RHODE ISLAND ATOMIC ENERGY COMMISSION
RESEARCH REACTOR
LICENSE NO. R-95
DOCKET NO. 50-193

RESPONSES TO NRC STAFF REQUEST FOR
ADDITIONAL INFORMATION
FOR LICENSE RENEWAL REVIEW

Power and Pump Flow for the RINSC LOF

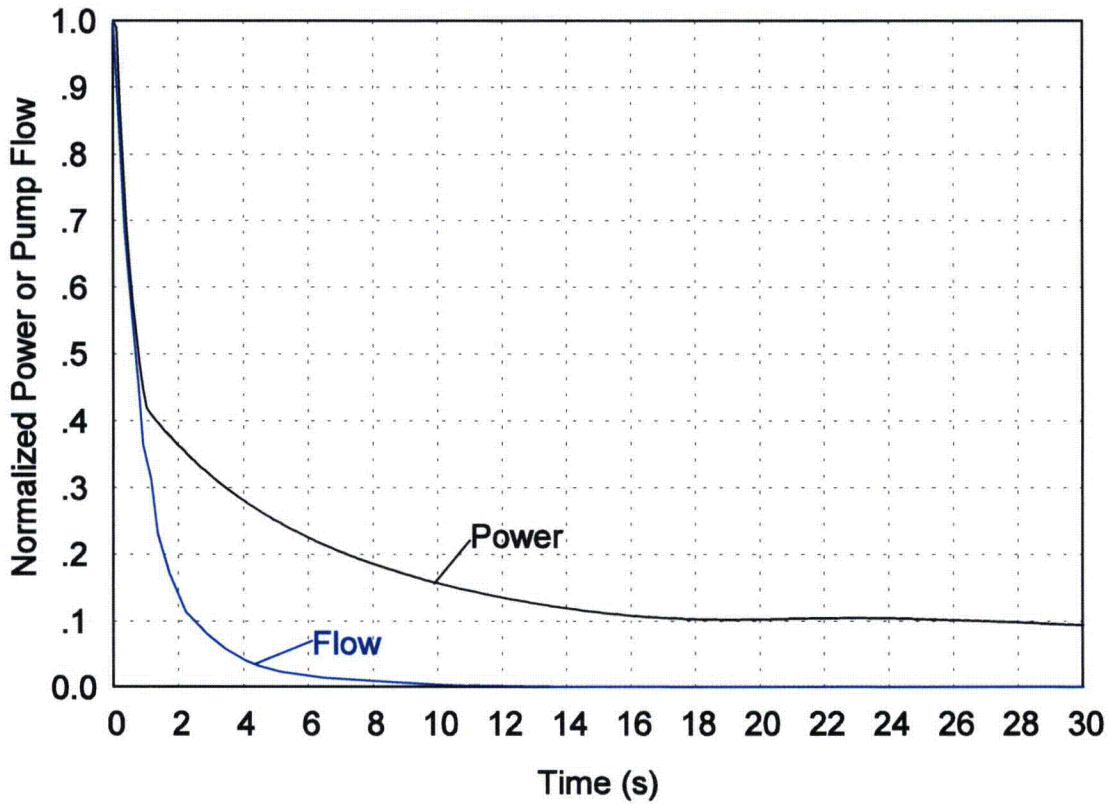
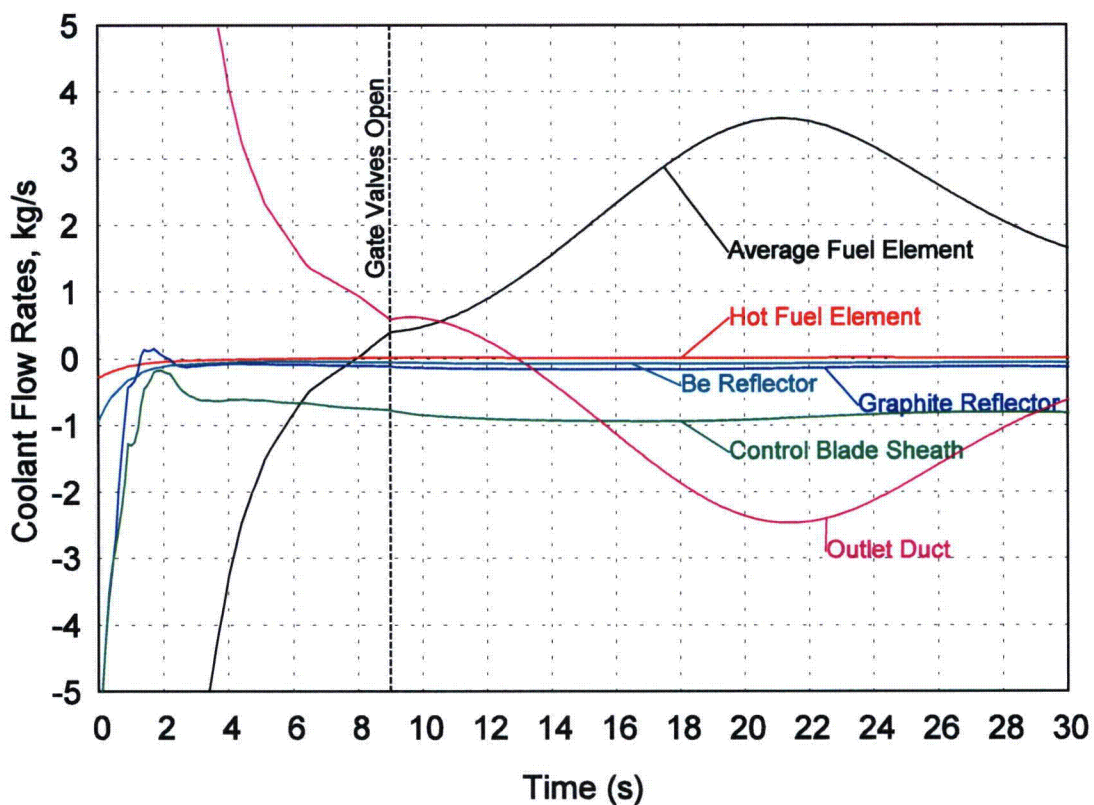
- 13.19 Section 13.2.4.1 states that the peak clad temperature during a loss-of-flow-accident induced by a loss of electrical power is 103 degrees C. Provide an analysis that supports this statement. Justify all assumptions made in the analysis.

The normalized power and pump flow for the base case are shown in the figure below. For the first second, while the control blades are inserting, the power and flow fall at about the same rate. After that the power falls slower, and the pump flow drops to zero.
